### Retailer Bulletin

#### E-Caliber pedal-assist issue

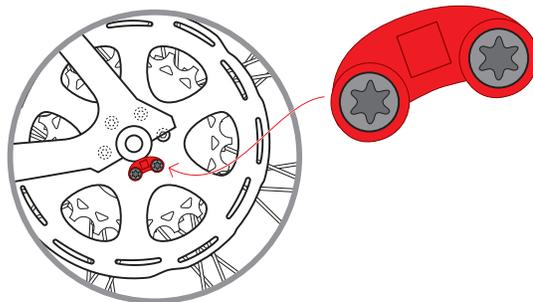
The speed sensor can count double or triple the revolutions of the back wheel. The magnetic field can come too close to the speed sensor and the Fazua system is not able to filter out the error.

1. Remove the magnet.

2. Flip the magnet around and reinstall it.

3. Test the bicycle to make sure the pedal-assist is working properly. If the pedal-assist is still not working properly, contact Trek Customer Care. The placement of the speed sensor may need adjustment.
